NP-11-0020
May 23, 2011

Subject: Exelon Nuclear Texas Holdings, LLC
Victoria County Station Early Site Permit Application
Response to Request for Additional Information Letter No. 07
NRC Docket No. 52-042

Attached are responses to NRC staff questions included in Request for Additional Information (RAI) Letter No. 07, dated April 8, 2011, related to Early Site Permit Application (ESPA), Part 2, Sections 02.04.06, 02.05.02, and 11.02. NRC RAI Letter No. 07 contained twenty (20) Questions. This submittal comprises a partial response to RAI Letter No. 07, and includes responses to the following seven (7) Questions:

Figure 1. Schematic map showing locations of VCS and STP sites, and seismicity parameters in nearby degree cells for Rondout source 51. The dashed orange line marks the source boundary.

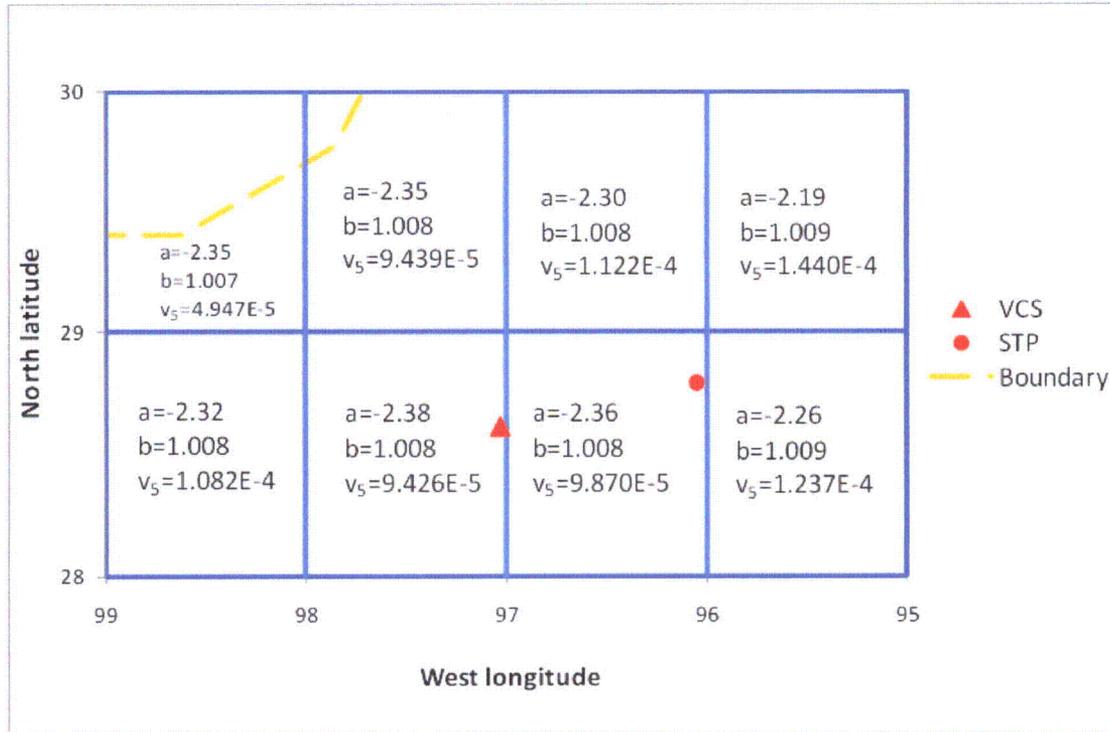
SSAR Section 2.5.2.4.1 describes software validation using EPRI hazard calculations. The applicant indicated that the lower overall hazard calculated for each of the EPRI ESTs at the VCS site relative to the STP site is attributed to three factors, 1) ~60-mile difference in location; 2) the VCS site lying within a geographical degree cell that has lower seismicity than that of the STP site; and 3) undocumented modeling assumptions. Please explain, in detail, how these three factors combine to produce a lower hazard at the VCS site relative to the STP site.

Figure 1 shows a schematic map with the VCS and STP locations, and shows seismicity parameters in nearby degree cells. Parameters a and b are taken from EPRI-SOG files for Rondout source 51, which is the background host source for both sites. Note that low smoothing on a and constant b were specified for this source, so it depicts the spatial variation of seismicity. Also shown is parameter v_5 , which is the rate of earthquakes with $m > 5.0$ in that degree cell. Parameter a is the logarithm of the rate of earthquakes with $3.3 < m < 3.9$ in that degree cell, per equatorial square degree. Note that parameter v_5 accounts for the size of the degree cell within the source, whereas parameter a does not.

Figure 1 shows that the VCS site and the STP site each lie close to a whole number longitude line. A summary of the average rate parameter v_5 , for the adjacent 2 degree cells surrounding each site (the host cell and the next cell east) and for the adjacent 4 degree cells surrounding each site (the two cells just described, plus the two cells immediately north) is as follows:

Site	Average v_5 for adjacent 2 cells	Average v_5 for adjacent 4 cells
VCS	9.648E-05	9.989E-05
STP	1.112E-04	1.197E-04
VCS rate:	lower by 13%	lower by 17%

This comparison shows that seismicity in the host source (for Rondout source 51) near the VCS site is 13% to 17% lower than seismicity near the STP site, because of the location of the VCS site in a different degree cell (about 60 miles west of the STP site).

Figure 1. Sensitivity of 0.5 Hz rock hazard to ground motion equation for New Madrid faults.

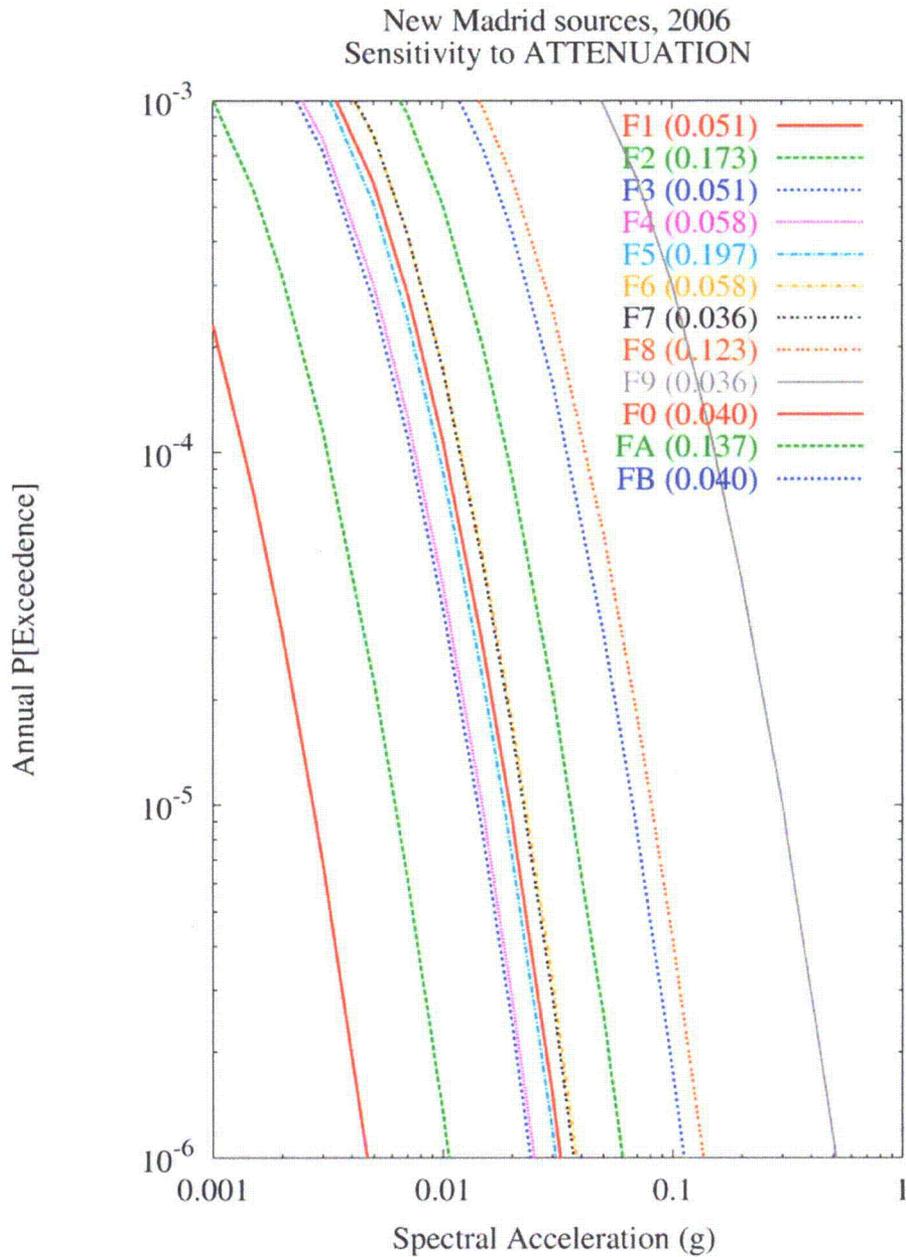
- a) SSAR Figure 2.5.2-18 shows the 10 Hz mean rock hazard curves for the New Madrid seismic zone (NM) only and the EPRI-SOG+NM. SSAR Figure 2.5.2-24 shows the mean rock seismic hazard curves by source for each EPRI EST source and the New Madrid source. Please explain why the total hazard [EPRI-SOG+NM curve] in SSAR Figure 2.5.2-18 does not appear to reflect the sum of the individual hazard curves in SSAR Figure 2.5.2-24.
- b) In SSAR Figure 2.5.2-38, the mean hazard curve exceeds the 95 percentile hazard curve at 0.09 g and above. Please explain this result.

In SSAR Figure 2.5.2-38 the mean hazard curve exceeds the 95 percentile hazard curve at ground motions of 0.09g and above because the percentile hazard curves include epistemic uncertainty in ground motion equations, and there is a large range of hazard over this epistemic uncertainty. This range is illustrated in Figure 1, which shows contribution by ground motion equation for the NM source (this source contributes virtually all seismic hazard for low spectral frequencies, as shown in SSAR Figure 2.5.2-19 for 1 Hz spectral acceleration). In Figure 1, the ground motion equation labeled "F9" is the highest curve and this dominates the calculation of the mean hazard. As an example, the following table shows an approximate, illustrative calculation of mean hazard for 0.5 Hz spectral acceleration at 0.09g (taken from the curves illustrated in Figure 1), using only the highest 3 hazard curves in that figure:

Ground motion equation	Weight	Approximate hazard at 0.09g	Weighted hazard (weight x approx. haz.)
F9	0.036	4×10^{-4}	1.4×10^{-5}
F8	0.123	7×10^{-6}	8.6×10^{-7}
FB	0.040	3×10^{-6}	1.2×10^{-7}
Total mean hazard	—	—	1.5×10^{-5}

The last row in the above table sums the weighted hazards from the highest 3 hazard curves, and shows that the approximate total mean hazard is 1.5×10^{-5} (which agrees with the “mean” curve in SSAR Figure 2.5.2-38 at 0.09g), and that the dominant contribution to this hazard comes from the highest ground motion equation “F9”. Since only one hazard curve lies above this hazard at 0.09g (ground motion equation “F9” with a weight of 0.036), it is reasonable that the total mean hazard lies at about the 95 percentile of epistemic uncertainty in hazard at 0.09g.
